16th August 2022
Rev 2 – 17.8.22

RE: FORMER BARTONS INFANT SCHOOL, BERSTED
Council Ref: BE/40/22/PL

Technical Note in response to LLFA comments

Drawing Number	11642/1601	Rev.	P5
----------------	------------	------	----

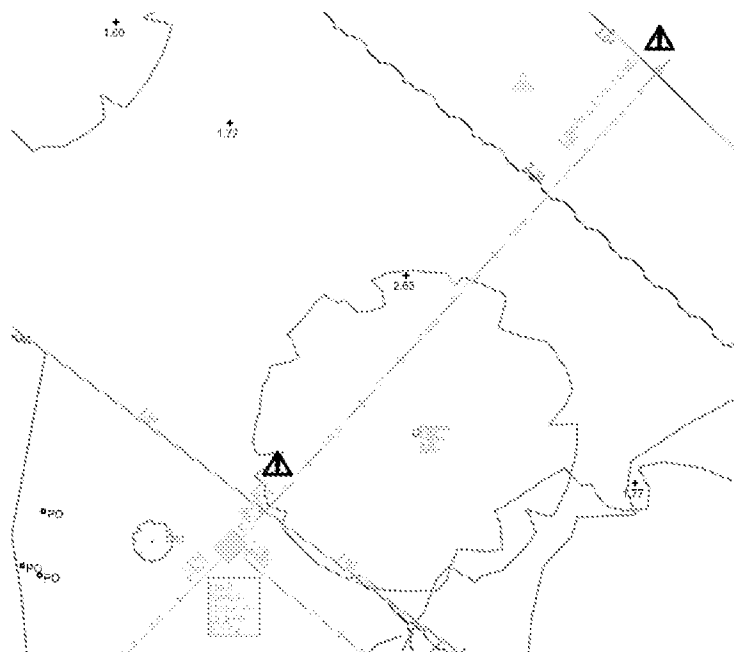
- 4) We require the fences to be at least 3m from top of bank, between the development and ancient watercourse, to ensure that the proposals are in accordance with our land drainage byelaws. This easement should be delineated and confirmed on the drainage layout plan.
- From the information provided it appears that a 2m easement (approximately) has been provided for access and maintenance of the watercourse at present. It is recognised that no buildings are located within 5m (as is also required).

We have clarified the location of the top of bank of the watercourse and shown a 3.5m easement to a relocated fenceline location on amended drawing 11642/1601 rev P5 appended.

P5	Tank volume increased to take into account urban creep. Stream buffer shown.	16/08/2022	JR	MR
P4	LATEST TREE RETENTION PLAN ADDED. PLOTS 20&21 FFL'S CHANGED TO 3.850.	14/04/2022	JR	MR
P3	SITE BOUNDARY AMENDED TO SITE WORKS LINE.	29/03/2022	KK	JR
P2	REVISED TO LATEST SITE PLAN	04/02/2022	KK	JR
P1	INITIAL ISSUE	31/01/2022	KK	MR
Rev	Amendments	Date	Dis	Chk

Extract of utilities survey showing existing school outfall

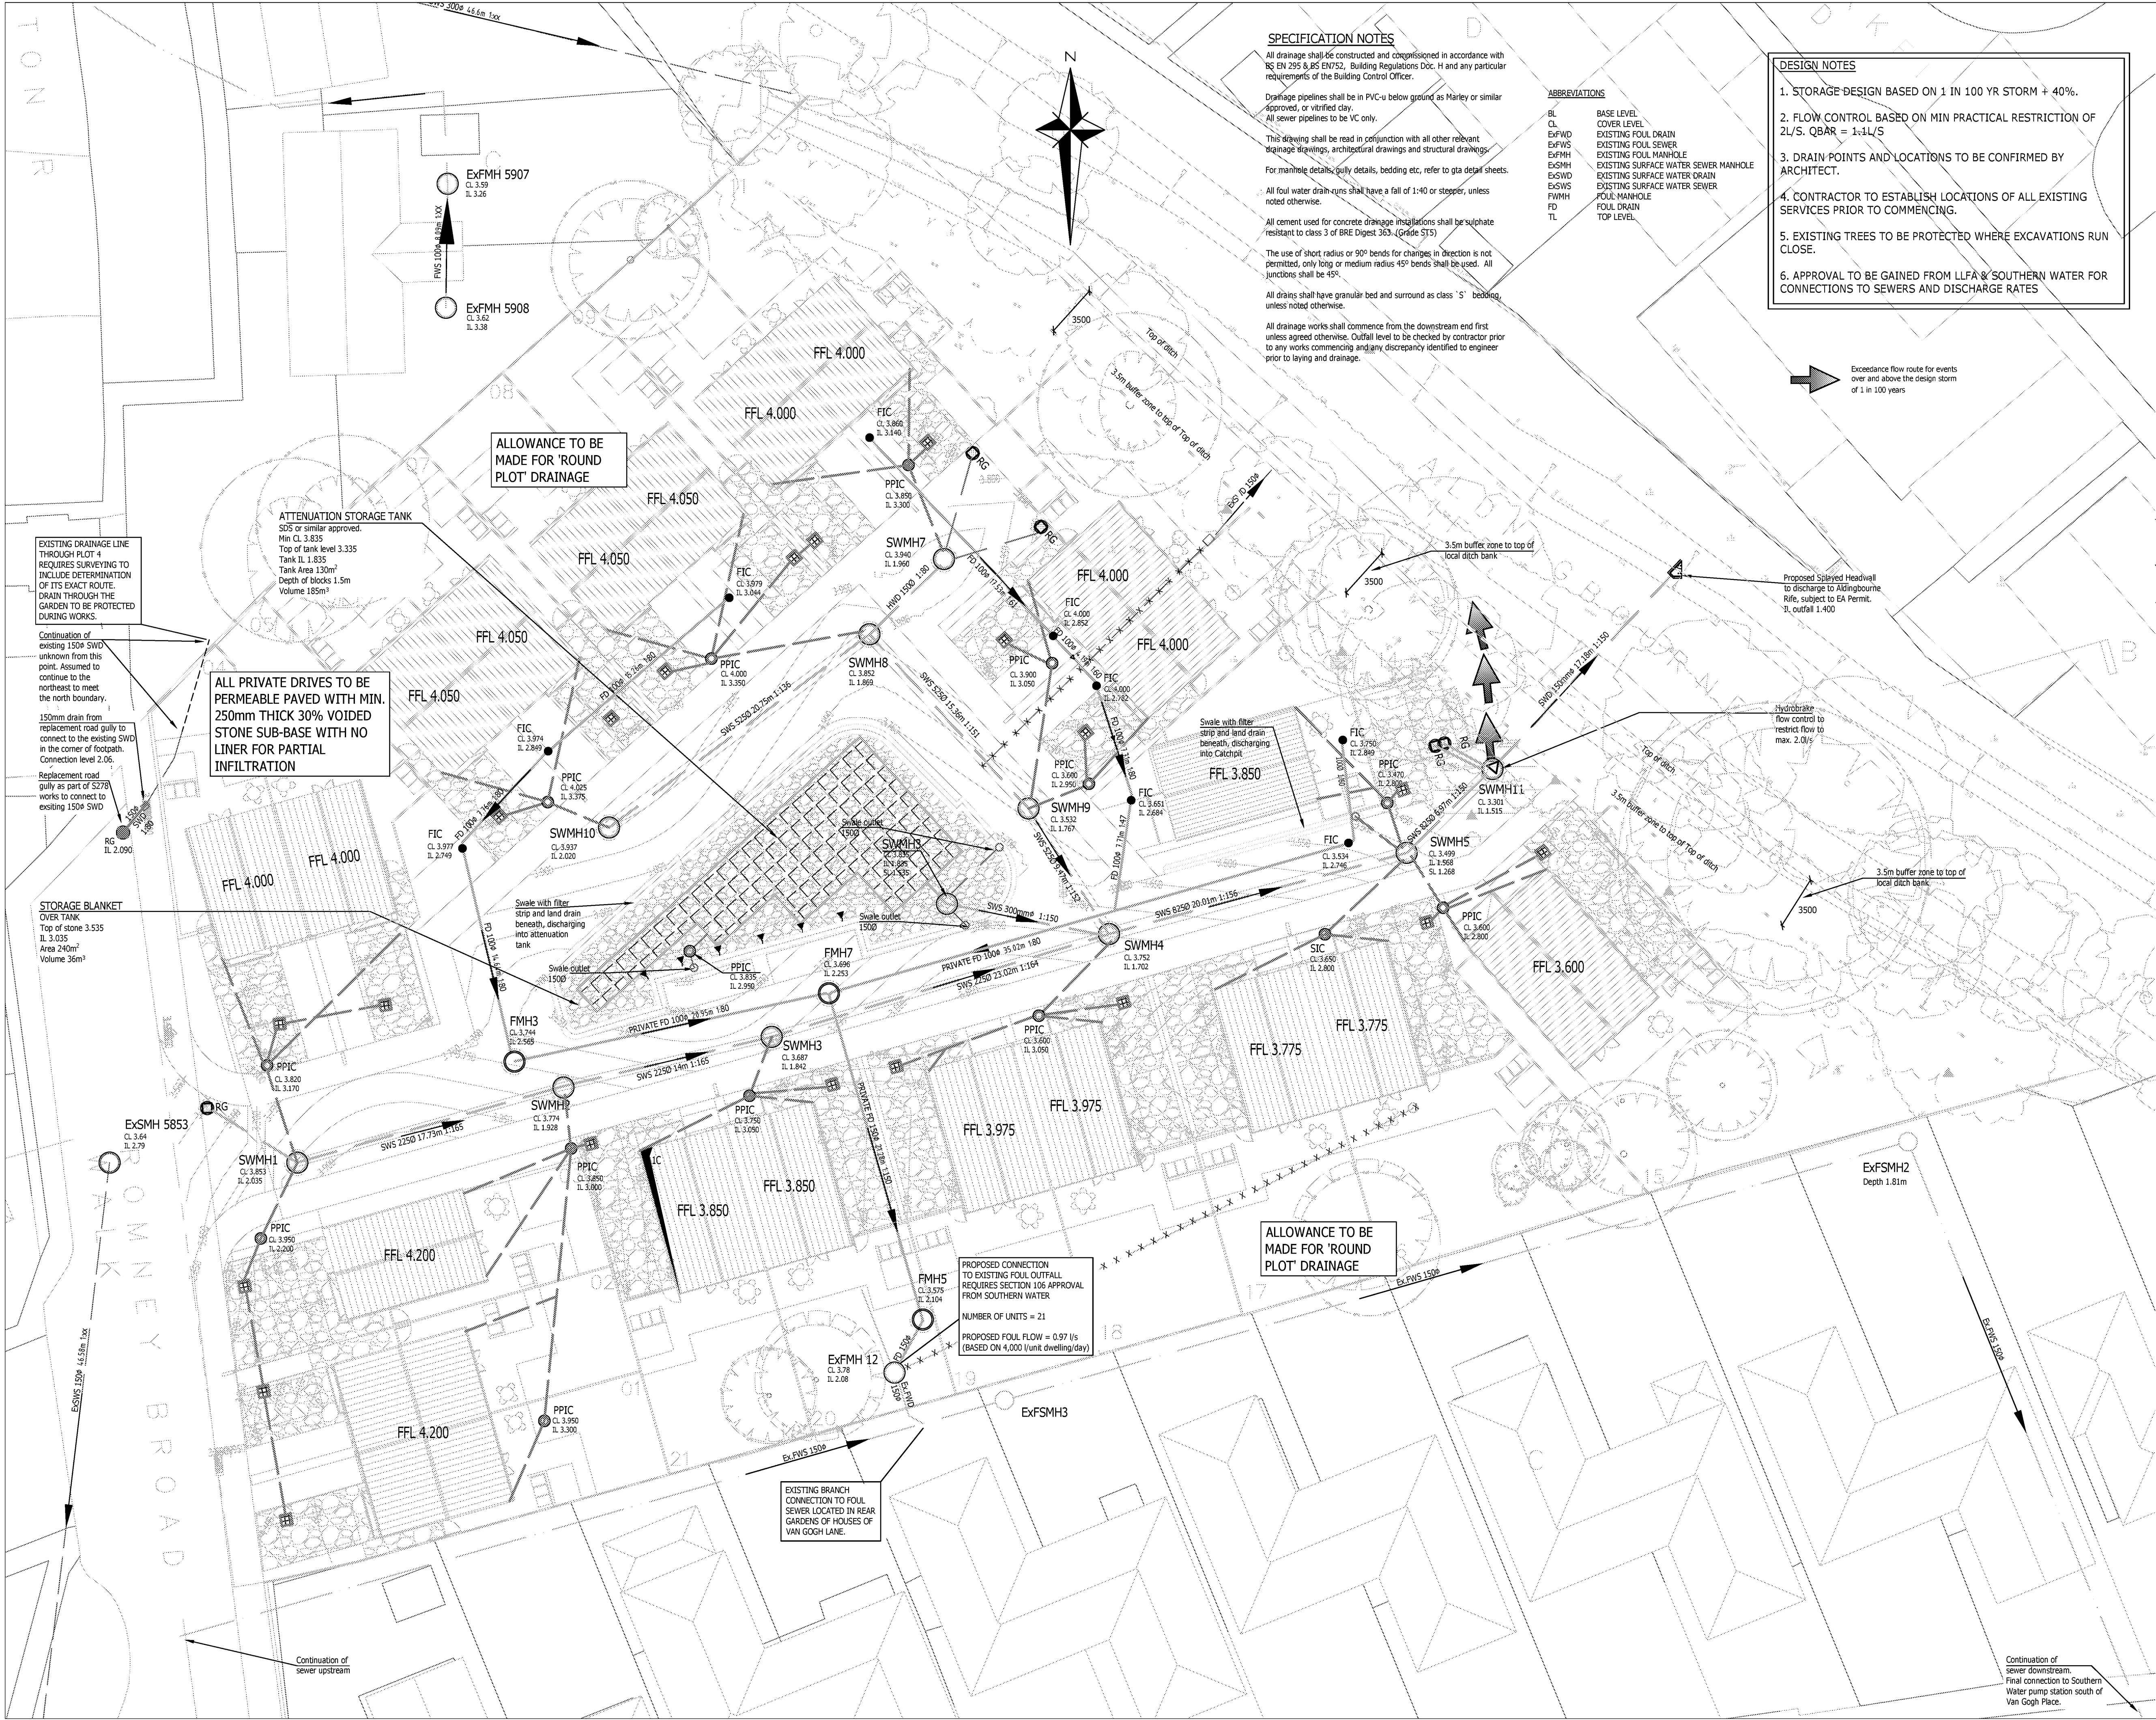
- 5) We are unsure how the ditch / small watercourse adjacent to the site connects to the nearby main river and we have concerns regarding how onward connection from the development site to this watercourse, or the main river will be achieved.

- The drainage layout shows the proposed onward connection to the main river crossing the smaller ditch channel. There is likely to be works required to facilitate the connection as shown, or to ensure the ditch / small channel is fit for purpose and has onward connectivity to the main river if a connection to this feature is proposed at the detailed design stage.

- We require additional details of the proposed connection, including whether an existing connection between the main river and smaller channel is present.

- We require details of how any pipework can be accommodated / will pass through the area where the existing ditch / channel is. This pipework should remain above the water level within the main river.

We have searched the area and we cannot find connectivity between the small watercourse and main river due to dense undergrowth.

The proposed connection is mimicking the existing school outfall location which is shown on the survey plan appended, extract below:

The only reason this existing outfall was not used was that it is not in a convenient location for future maintenance, as the manhole falls in the garden of plot 13.

The level of the existing outfall is likely to be somewhere in the region of 1.4m AOD (as upstream chamber is 1.54m) which is what we are proposing, so the new outfall will have no more impact than the existing, especially taking into account this used to have no flow restriction from the school site.

The main rife ditch bed level has been surveyed at approximately 1.020m AOD in the vicinity of the connection with no water level in the rife present. So the connection is 380mm above bed level which we feel is more than sufficient.
